COMMUNITY DEVELOPMENT  
DEPARTMENT REPORT

HEARING DATE: 1/14/2025  
TO: Mayor & City Council  
FROM: Bill Parsons, Current Planning Supervisor  
208-884-5533  
bparsons@meridiancity.org  
APPLICANT: Amanda McNutt, Brighton Corporation  
SUBJECT: H-2024-0052  
Apex Zenith  
LOCATION: Generally located at the southeast corner of Meridian Road and Lake Hazel in the east 1/2 of the northwest 1/4 of Section 6, T.2N., R.1E.

D. Concept Plan (date: 10/8/2024)

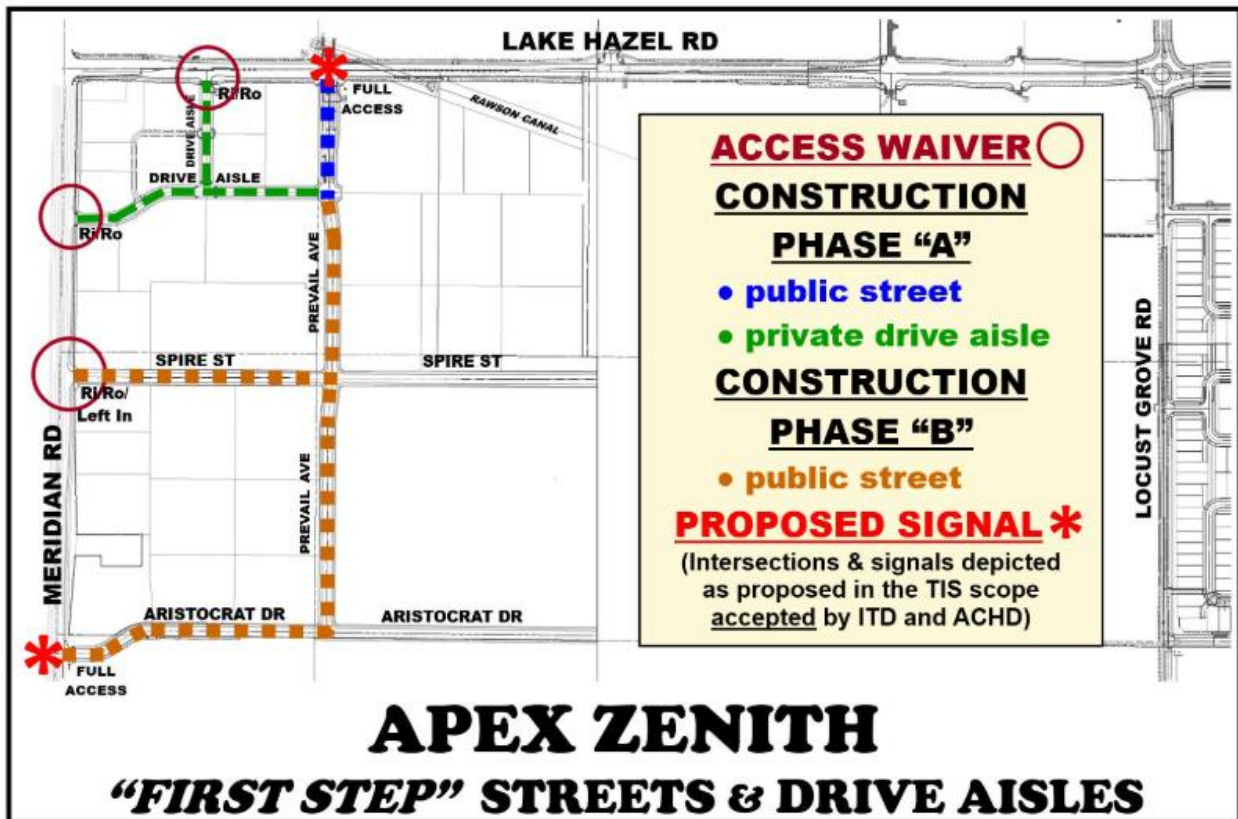
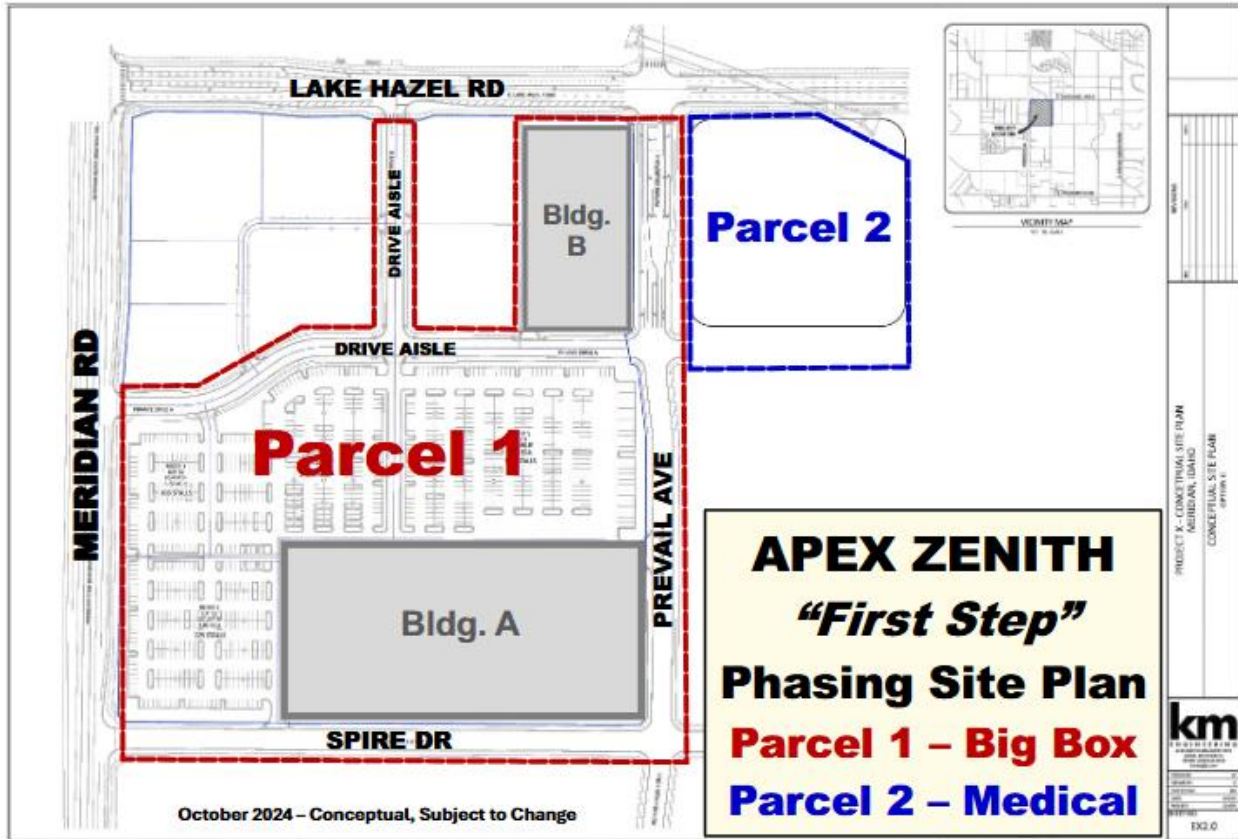
<p>For mixed-use developments, at least 40% of the buildable frontage must be occupied by building facades or public space.</p>	<p>The current concept plan shows no building frontage along Meridian Road. To satisfy the 40% requirement for phase one, the applicant should relocate the building to the Meridian Road frontage. After discussing with the applicant, they would like to defer the building frontage to phase two. This would require approximately 2,017 feet of building frontage along State Highway 69 and E. Lake Hazel Road when excluding the anchor tenant's frontage. This will be a requirement in the development agreement.</p>	<p>1</p>
<p>No more than 50% of the total off-street parking area for properties over two acres can be located between building facades and abutting streets.</p>	<p>In compliance with this standard. Future development will be evaluated with the development agreement modification in phase two.</p>	<p>1 and 2</p>

Based on the concept plan, the applicant does not fully comply with the standards outlined in UDC 11-3A-19. While they meet the requirement that no more than 50% of the total off-street parking area for properties over two acres can be located between building facades and abutting streets, they do not meet the building frontage requirements due to the proposed building location.

For mixed-use developments, at least 40% of the buildable frontage must be occupied by building facades or public space. The current concept plan shows no building frontage along Meridian Road. To satisfy the 40% requirement for phase one (1), the applicant should relocate the building to the Meridian Road frontage. Staff recommends sliding the building to the west and positioning it along this road.

sidewalks are proposed along Spire Street and private drive aisles in the northwest corner. Staff recommends adding 5 feet sidewalks along the portion of the site between the proposed medical offices and future MHDR residential. This will allow the applicant to meet the comp plan goals listed above.

- f. For mixed-use developments, a minimum of 40% of the buildable frontage must be occupied by building facades or public space. The applicant shall either move the proposed anchor tenant building along Meridian Road frontage or provide a minimum of 40% building frontage with phase two.
